**BOUNTIFUL CITY
PLANNING COMMISSION AGENDA
TUESDAY, JUNE 16, 2026
6:30 P.M.**

Planning Commission Staff Report

Subject: Preliminary & Final Plat Approval of the North Canyon Towns PUD Subdivision and Architectural & Site Plan at 460 West 2600 South

Author: Amber Corbridge, Senior Planner

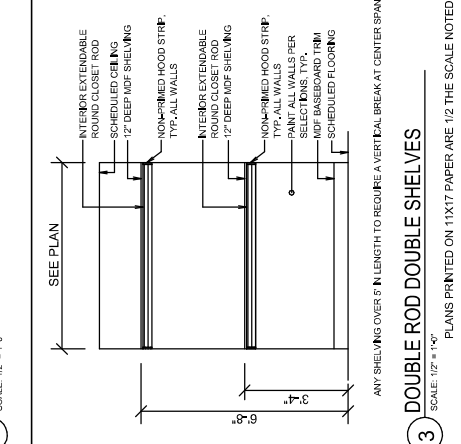
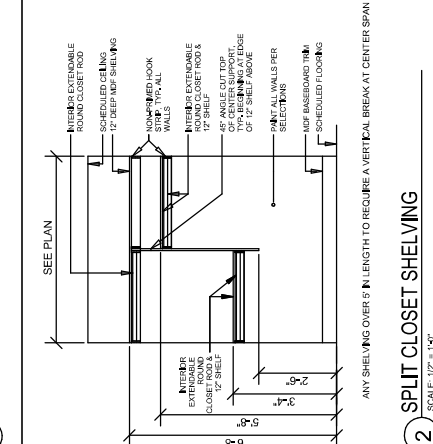
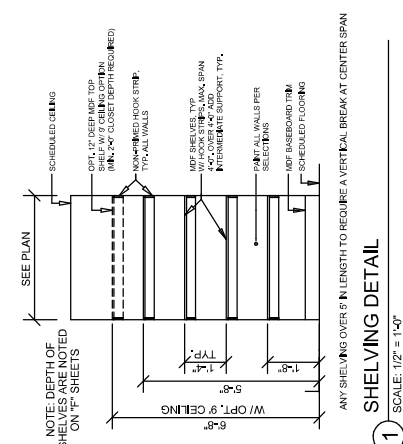
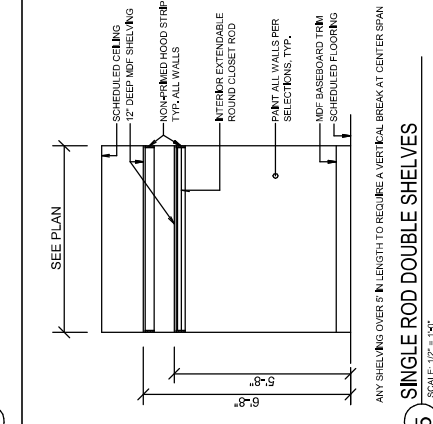
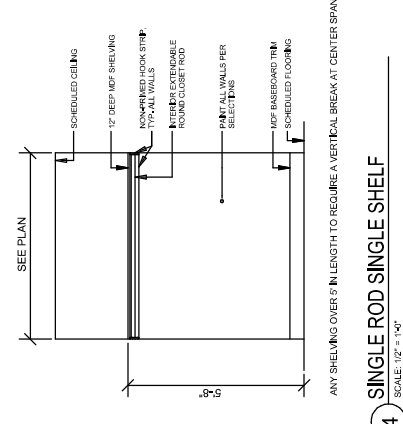
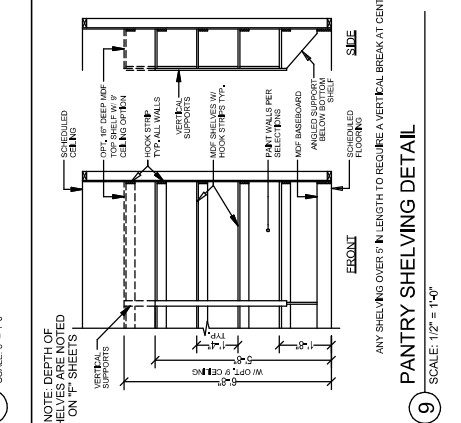
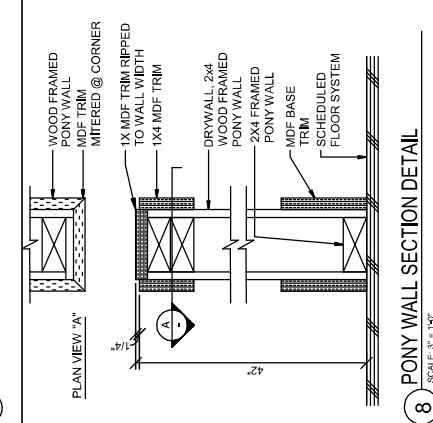
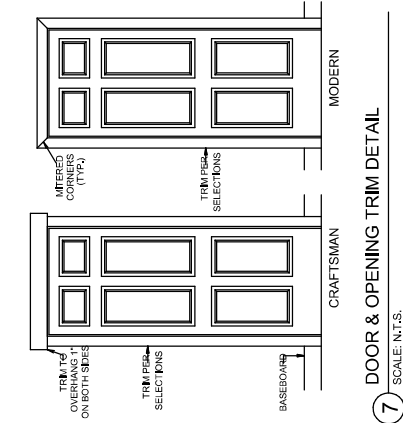
A. Show how external utilities/storage meet screening:

2. Screening devices and landscaping shall be used to mitigate the visual impact of utility equipment and service areas.

B. Show percentages and areas for exterior building materials.

C. Is there proposed signage for this project?

A. Air conditioning condensers will be located behind the garages, where they will be out of view from the front and either side of the unit. See sheet A2.02 for proposed locations.

Electrical and gas meters will be placed on the interior side yards of each building, out of view from the primary frontage. Utility meters will also be screened with Ivory Halo Dogwood, as shown on the current landscape plan.

- Brick - 59%
- Stucco - 26%
- Board and Batten - 15%
